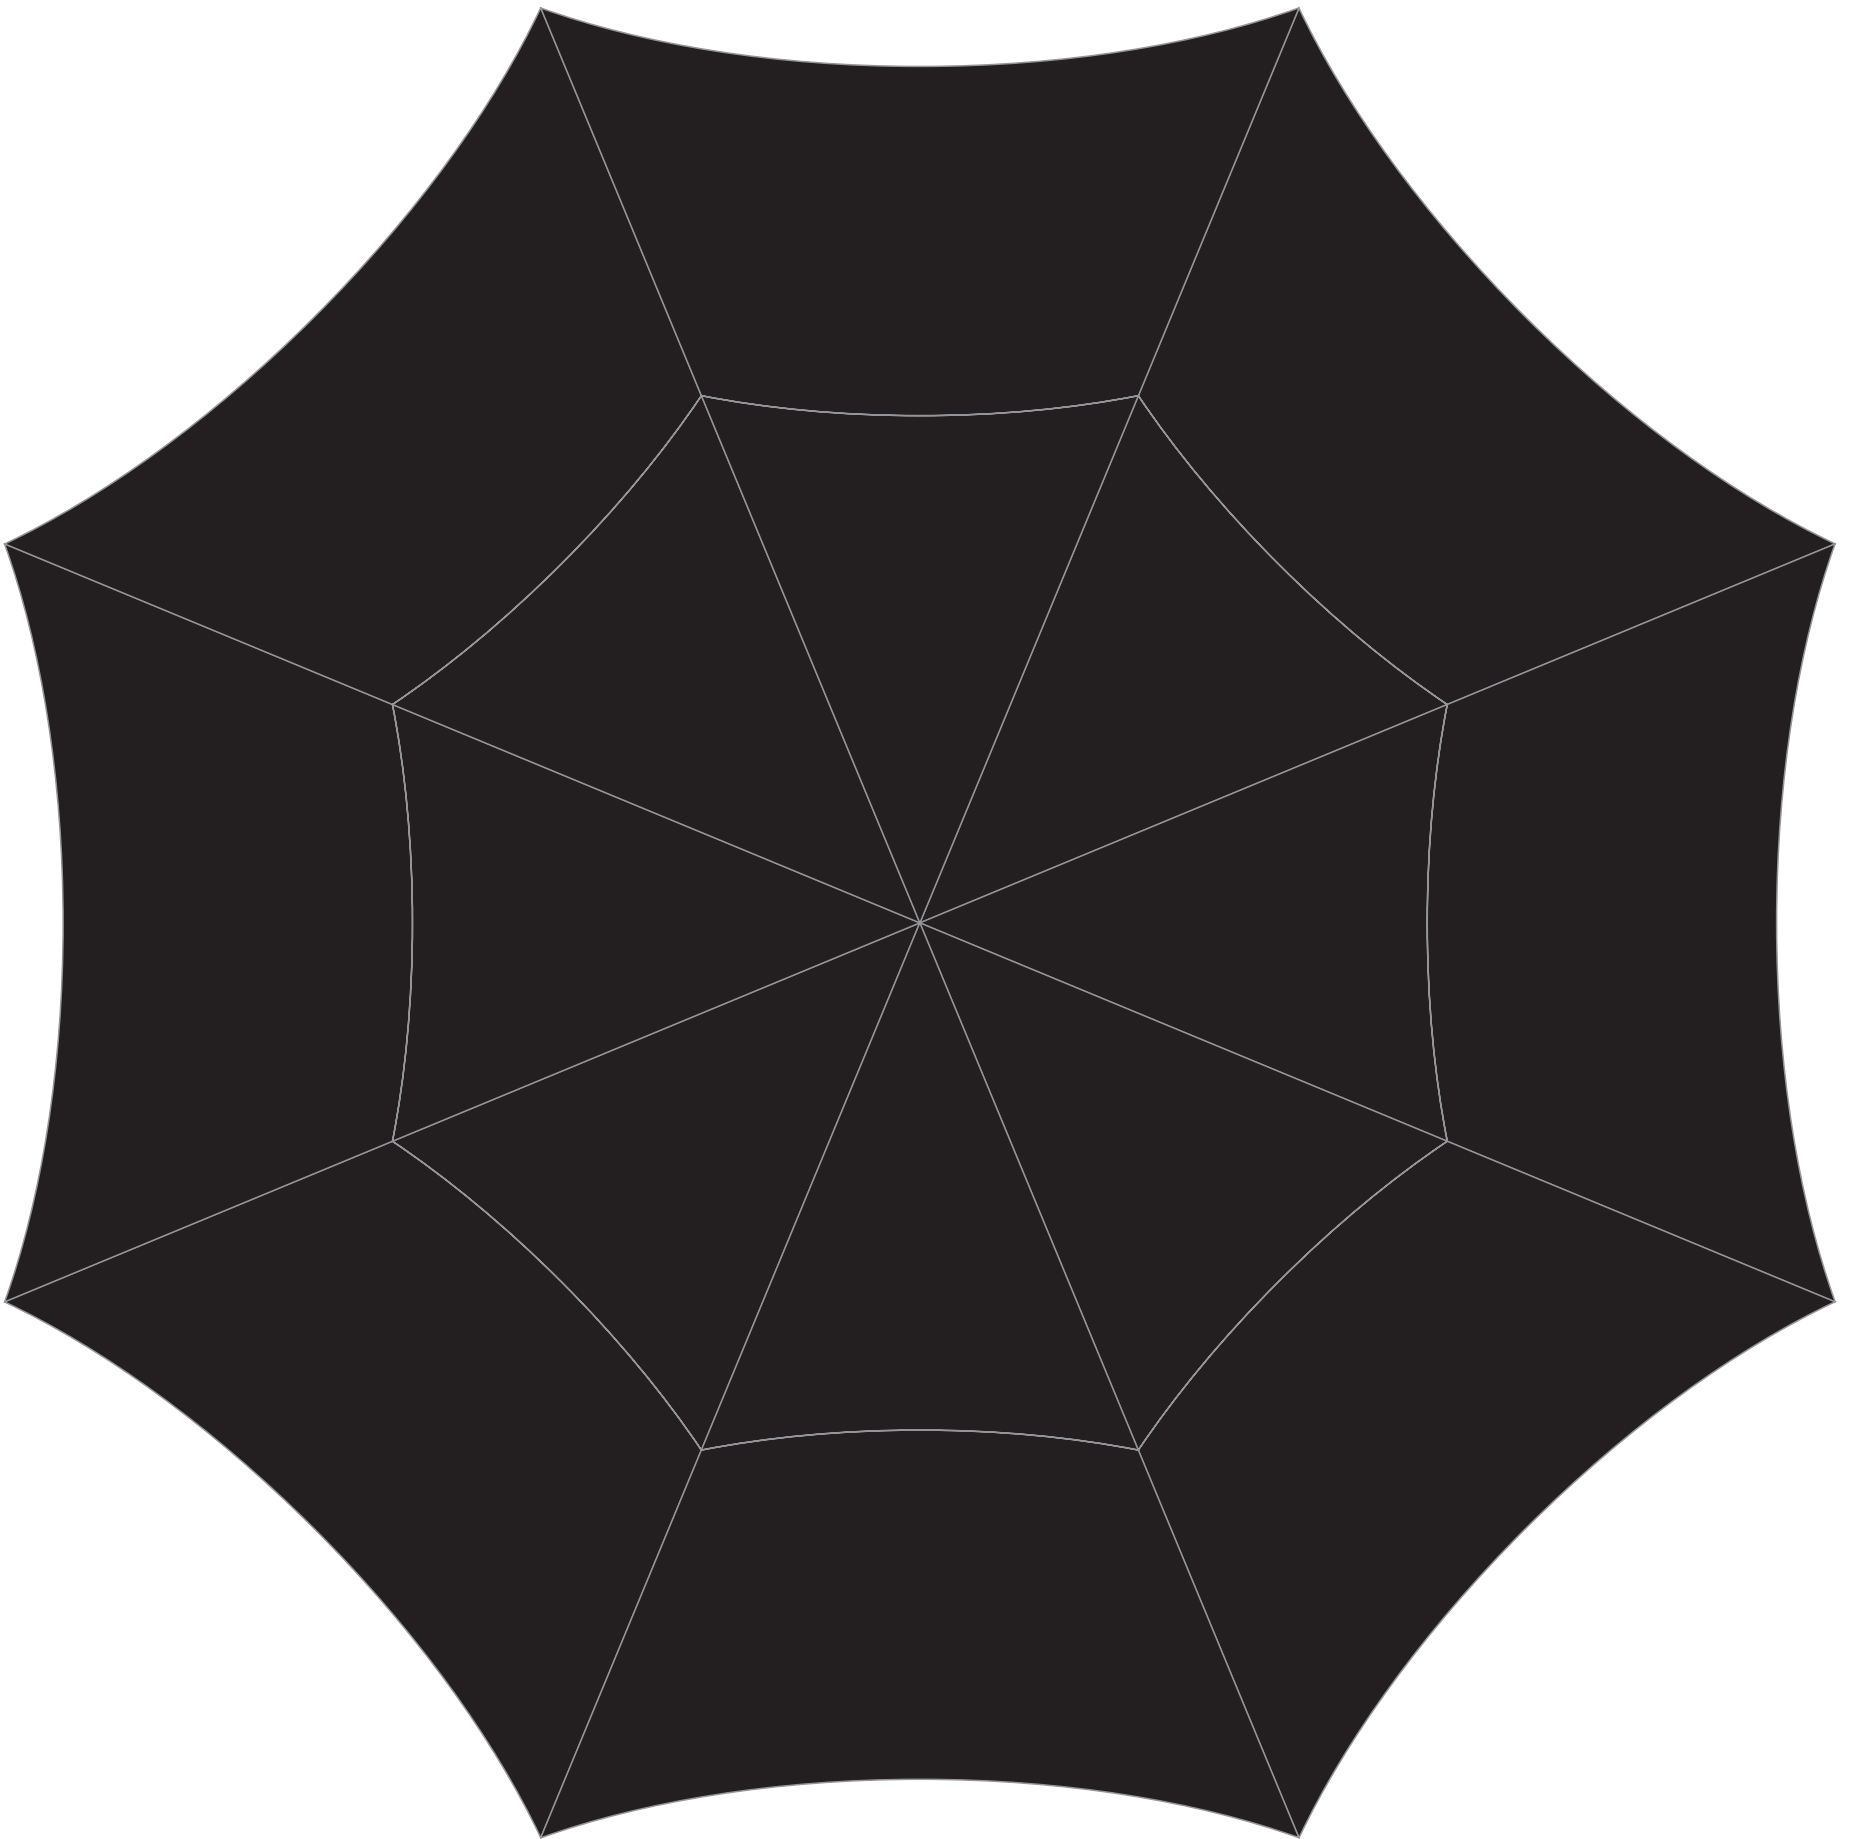
There is 22cm from edge of umbrella to the wind vent.
Normally we don't print any higher than 16 - 17cm in
height so that the ink doesn't transfer onto the top of the
panel when printing
